UNITED STATES PATENT AND TRADEMARK OFFICE

APPLICATION NO.	FILING DATE	FIRST NAMED INVENTOR	ATTORNEY DOCKET NO.	CONFIRMATION NO.
10/560,074	06/23/2006	Thomas Scherb	P28845	9642
7055 7590 05/21/2009 GREENBLUM & BERNSTEIN, P.L.C. 1950 ROLAND CLARKE PLACE RESTON, VA 20191				
EXAMINER FORTUNA, JOSE A				
ART UNIT		PAPER NUMBER		
1791				
NOTIFICATION DATE		DELIVERY MODE		
05/21/2009		ELECTRONIC

Office Action Summary

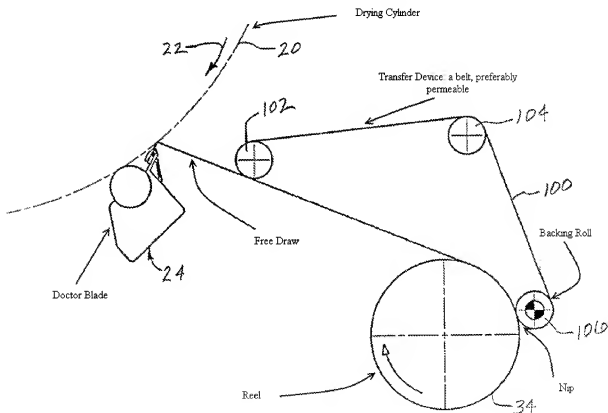
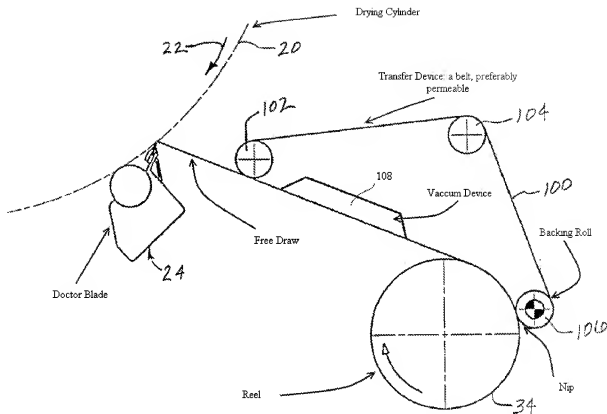
Linden teaches a device for producing a tissue web which includes a drying cylinder that could be a Yankee Dryer, a creping Doctor and winding device to reel-up the web onto a roll and a transfer device that carries the web from almost the entire run from the doctor blade to the winding roll, see figure 7B and ¶-[0053]. The figure shows also that the web is unsupported, creating a free draw from short distance from the doctor to the beginning of the transfer device, and shows that the web is supported on one side of the transfer

device. Linden shows also that the device can include a nip, formed by a backing roll and the reel, see for example ¶-[0053]. Figure 7F shows an embodiment in which the web is formed using a crescent former and through-air-dried (TAD) having hoods. Linden teaches also that the transfer device can be a belt; preferably a permeable belt and that vacuum can be applied to the web through the permeable belt. The device can be a vacuum box or a device that creates under pressure by blowing air via the Coanda effect, ¶-[0053] and Figures 7B and 7C, see below:

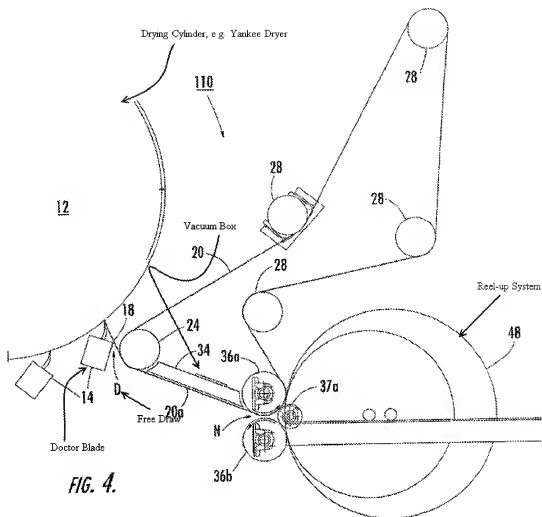
Clarke et al. teach a device for producing a tissue web which includes a drying cylinder, that could be a Yankee Dryer, a creping Doctor and winding device to reel-up the web onto a roll and a transfer device that carries the web from almost the entire run from the

doctor blade to the winding roll, see figures, specially figure 4, and ¶-[0036]-[0038]. The figure show also that the web is unsupported, creating a free draw from short distance from the doctor to the beginning of the transfer device, and show that the web is supported on one side of the transfer device. Clarke teach also that the short Draw, (D) can be changed from 4 inches to 48 inches, (0.1 to 1.20 meters), which falls within the claimed range, see ¶-[0024]. Clarke et al. show also that the device can include a nip formed by a backing roll and the reel, see figure 4 and ¶-[0036]-[0038]. Clarke et al. teach also that the transfer device can be a belt; preferably a permeable belt and that vacuum can be applied to the web through the permeable belt. The device can be a vacuum box (34) or a device that creates under pressure by blowing air via the Coanda effect, ¶-[0030]-[00333] and Figures 4, below:

FIG. 21

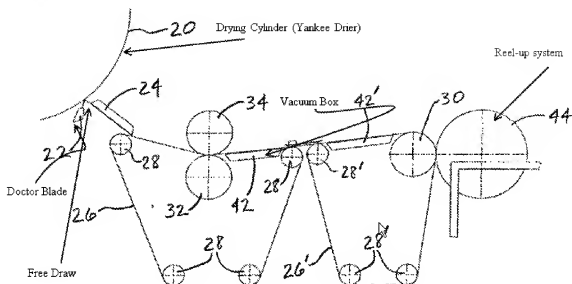
Klerelid et al. teach a device for producing a tissue web which includes a drying cylinder, that could be a Yankee Dryer, a creping Doctor and winding device to reel-up the web onto a roll and a transfer device that carries the web from almost the entire run from the doctor blade to the winding roll, see figures 1-21 and ¶-[0005]-[0014]. The figures show also that the web is unsupported, creating a free draw from short distance from the doctor to the beginning of the transfer device, and shows that the web is supported on one side of the transfer device. Klerelid et al. show also that the device can include a nip, formed by a backing roll and the reel, see for example figure 21, and ¶-[0069]. Klerelid et al. teach that the lineal pressure at the winding nip is controlled to be between 100-250 N/m (0.1 kN/m- 0.250 kN/m), ¶-[0071]. Klerelid et al. teach also that the transfer device can be a belt; preferably a permeable belt and that vacuum can be applied to the web through the permeable belt. The device can be a vacuum box or a device that creates under pressure by blowing air via the Coanda effect, ¶-[0040] and Figures 1-21, see figure 21 below:
